## Planning Officer's Report - LDCA May 2020

<b>APPLICATION</b>	2020/30 – Proposed Siting of the Replica Water Fountain
<b>PERMISSION SOUGHT</b>	Permission in Full
<b>REGISTERED</b>	25 March 2020
<b>APPLICANT</b>	Enterprise Saint Helena
<b>PARCEL</b>	JT0700015
<b>LOCALITY</b>	The Paved Area, The Canister, Jamestown
<b>LAND OWNER</b>	Crown
<b>ZONE</b>	Intermediate
<b>CONSERVATION AREA</b>	NCA
<b>PUBLICITY</b>	The application was advertised as follows: <ul style="list-style-type: none"><li>▪ Independent Newspaper on 27 March 2020</li><li>▪ A site notice displayed in accordance with Regulations.</li></ul>
<b>EXPIRY</b>	10 April 2020
<b>REPRESENTATIONS</b>	None Received
<b>DECISION ROUTE</b>	<del>Delegated</del> / LDCA / EXCO

**Diagram 2: Details of the Proposed Development Area**

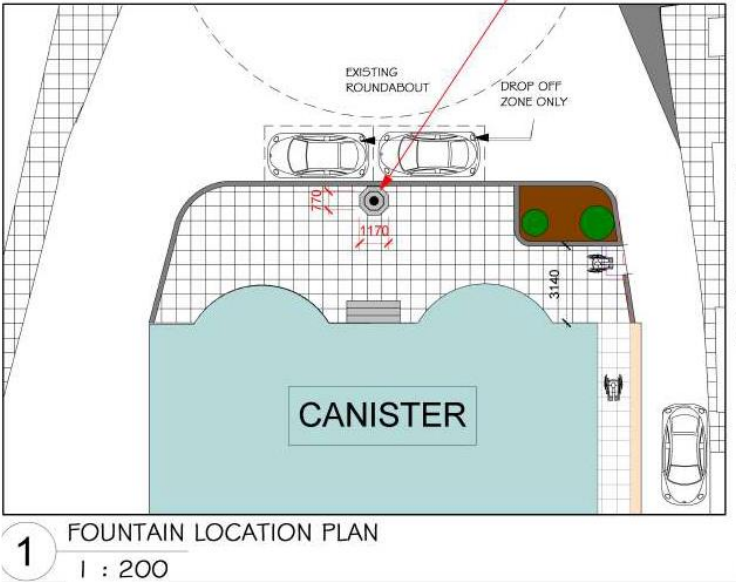
- the proposal for a plinth is shown as octagonal on one drawing and circular on the other and neither will be of sufficient size to accommodate the Canopy should one be obtained;

- position shown right on the edge on the pavement is also a hazard as it will never be possible to walk right around it without stepping onto the road and back up again.

The newly extended pavement area outside The Canister is still not considered to be wide enough to provide public art feature. The proposed erection of the public art in this location would there compromise pedestrian movement and the location of the feature should not be the edge of the pavement. There also two cap parking spaces in front the pavement, which are most part of the day occupied by parked cars and public art feature would therefore obscured by the parked vehicles in front and objective of the public art as landscape feature in the streetscene would hidden. In view of this the proposed location fails to meet the objectives of the policy.

**Diagram 3: The Replica Water Fountain**

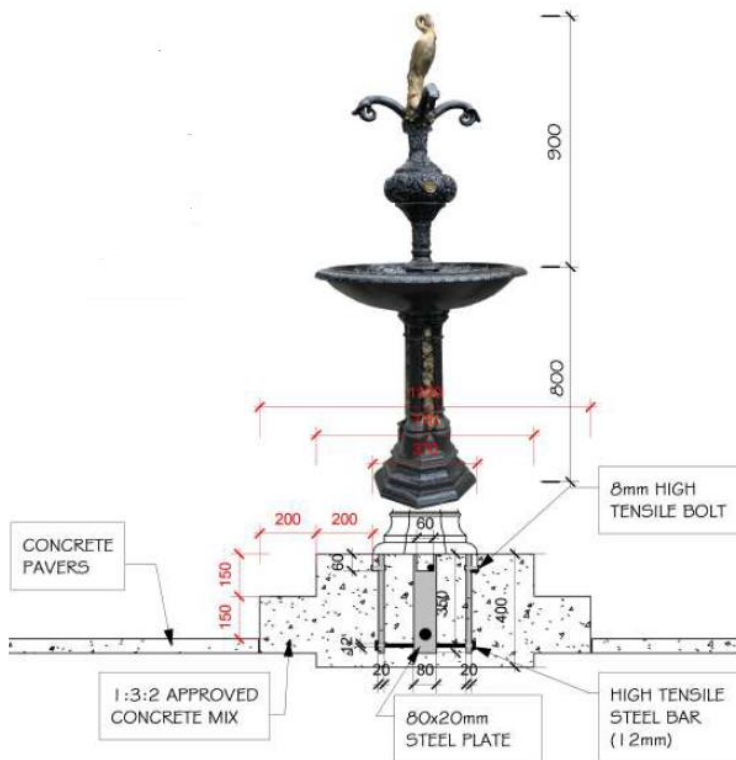
- Is an incomplete replica, without a canopy and a lantern, like the original and a fountain must have water spouting out and there is not water connection;
